SUBJECT: **LUC-2025-146 – 33 RUSSELL STREET**

Please find below my heritage comments for **application LUC-2025-146 – 33 Russell Street**.

LUC-2025-146 **SUBJECT: MIXED USE ACTIVITY WITH ANCILLARY PREMISE**

3 WATERS COMMENTS

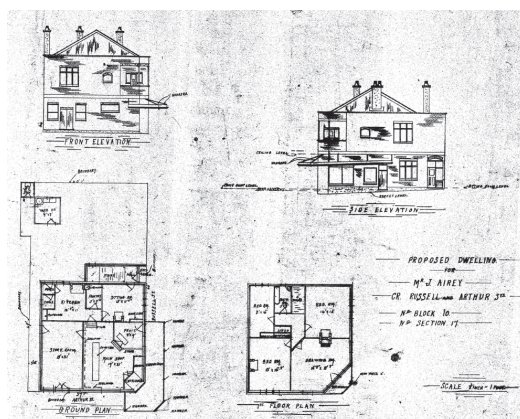
5. Note the heat pump marked as 'new' has already been installed and is a larger unit than that shown in the drawings.
6. The new commercial kitchen and bathroom require new ducting and air vents. The plans show the vents and ducts on the south wall. Two small air vents (150-200 mm ducting venting from the bathroom and kitchen) and a large (350mm) grease duct are proposed.

7. The south wall is visible when travelling north on Arthur Street. The grease duct to the roof fan is large and would be visually intrusive from the street and is not considered to be appropriately located (Rule 13.6.4.2.ii). The application does not indicate whether alternative locations or methods for installing the ducts were considered. These could include (in order of least to greatest visual impact from the street):

- Installing the grease duct internally and venting to the roof.
 - Running the grease duct horizontally to the rear of the building and then continuing it vertically to the roof. The adjoining residence would largely conceal the duct run. concealed by the adjoining residence.

- Shrouding the ducts to make them less intrusive.
8. The air intakes have covered vents. There is an existing air vent on the south elevation in a similar location. It is recommended that these vents match the colour of the existing wall to reduce their visual impact.

17. The proposed grease duct is visually intrusive, adversely affecting the heritage streetscape character. Adverse effects on the heritage streetscape character could be mitigated to an acceptable level. There may be other options for installing the ducts. These could include:

- **Option A:** Installing the grease duct internally and venting to the roof rather than mounting it on the exterior wall. The application does not indicate whether running the ducting internally has been considered or is possible.

- **Option B:** Running the grease duct horizontally to the rear of the building and then continuing it vertically to the roof. Running the grease duct to the building's rear would mean it was largely concealed by the adjoining residence. The application does not indicate whether this duct placement has been considered.

- Where the ducts will be visible, shrouding them to make them less intrusive.
 - Pairing the two extract ducts from the kitchen more closely and making them the same diameter to reduce their visual impact.
